*Traffic Analysis Review of Proposed Project:*

# **Rocketship Charter School**

## **Redwood City, CA**

March 31, 2017

Driveway with Blind Spots on Charter St

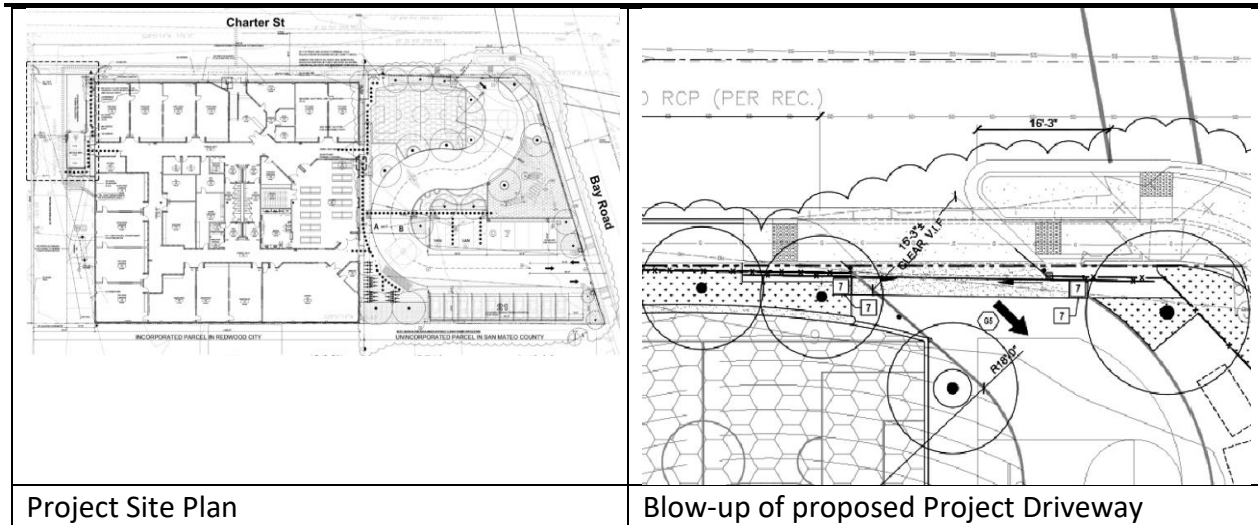
**PARKING ALREADY IN SHORT SUPPLY.** PRISM Engineering's observations of parking along Charter Street in the am peak hour on the section of Charter Street between Bay Road and Spring Street (the proposed charter school site frontage) indicate that during the am peak hour the parking on both sides of the street is completely saturated/occupied by vehicles and trucks. I also observed double parking, indicating that parking is already in short supply. The photos below show this condition, and show how there are blind spots for the numerous industrial business driveways. A child could be walking along the sidewalk, and because of a large truck or car parked immediately adjacent to the driveway, they cannot be seen (too short) by drivers on Charter Street. It is not inconceivable that a child could be easily hit by an incoming turning car or truck who did not see a child just about ready to enter the driveway but obscured behind the parked vehicle. Children also might even be running on the sidewalk (typical) just before a truck or vehicle enters one of these several driveways from Charter Street. An accidental vehicle/ped collision could easily take place. See example photos of some of these existing blind spots below.
